Question 1)

- a) Determine Design Current I_b

712.433.104 Protection of PV AC supply cable

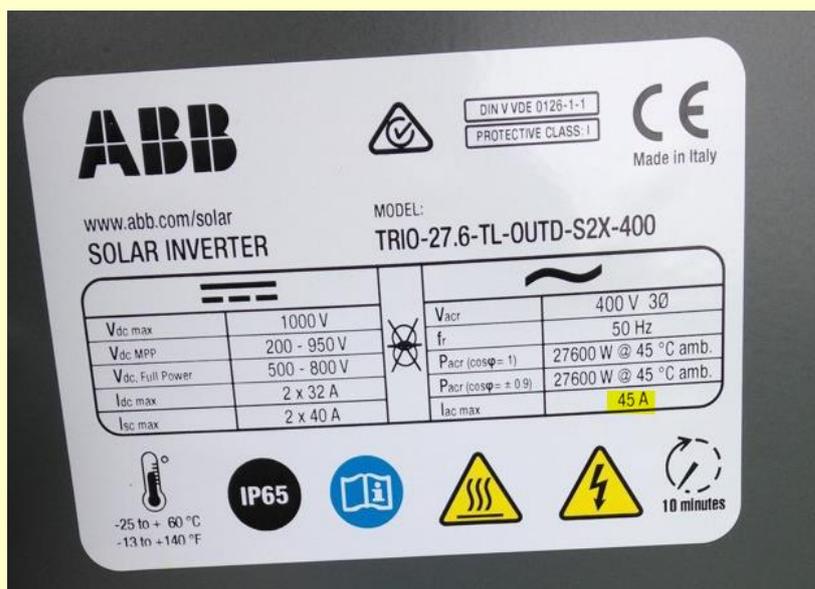
When defining the rated current of the overcurrent protective device for the AC supply cable, the design current of the inverter shall be taken into account.

The inverter design current is either the maximum AC current given by the inverter manufacturer or, if not available, 1.1 times its rated AC current.

$$\text{NEW calculated volt drop} = \frac{3.8 \times 45 \times 83\text{m}}{1000} = \underline{14.19 \text{ V}} \quad \checkmark$$

***Circuit does not comply as max VD is now exceeded!**

Let's try a 16mm then instead!

Fig 3A4 – Type B circuit-breakers to BS EN 60898 and RCBOs to BS EN 61009-1

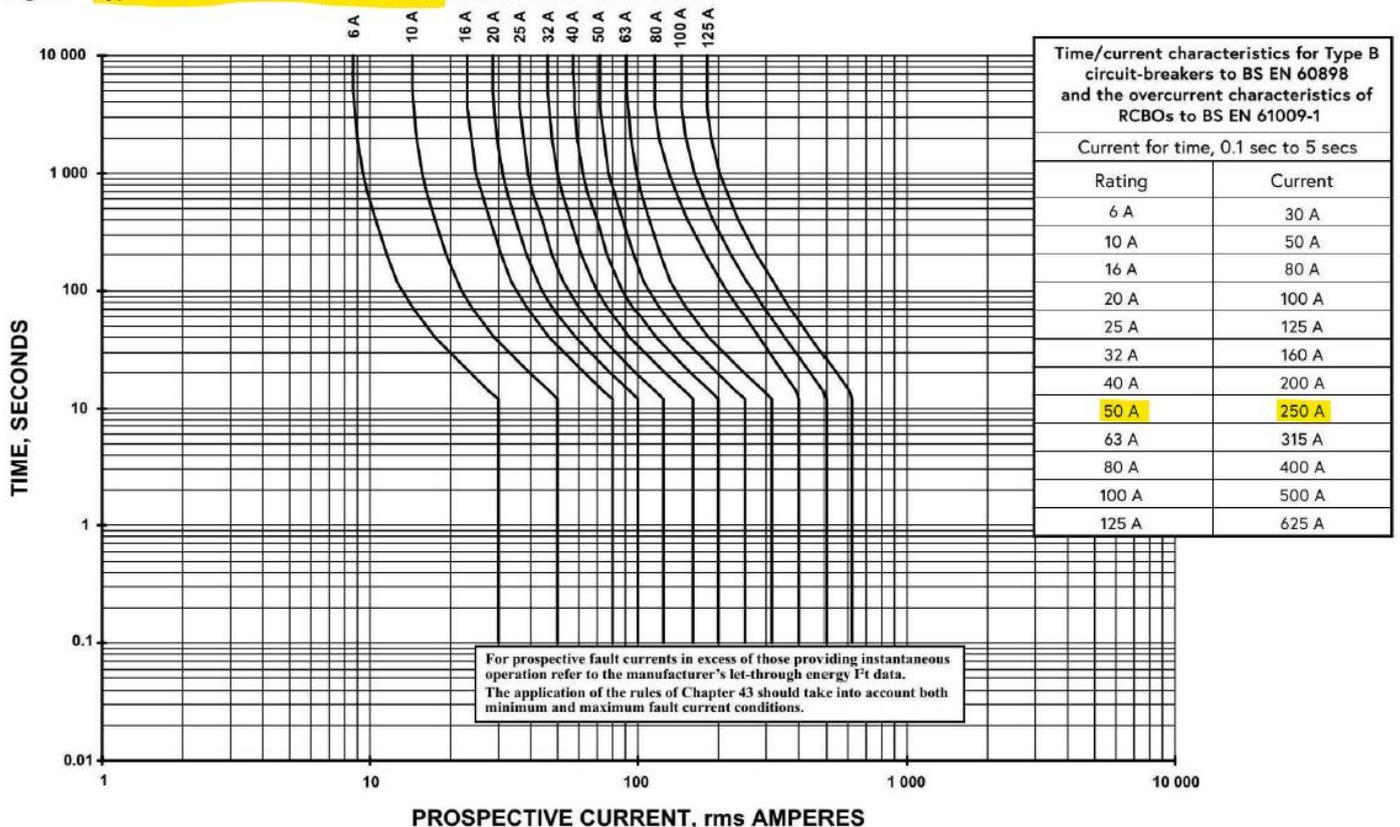
REMINDER: A minimum of 250 A is required to disconnect the 50 A Type B MCB between 0.1s to 5 seconds

Therefore, 1210 A is more than enough current for the protective device to operate in the event of a short-circuit fault!
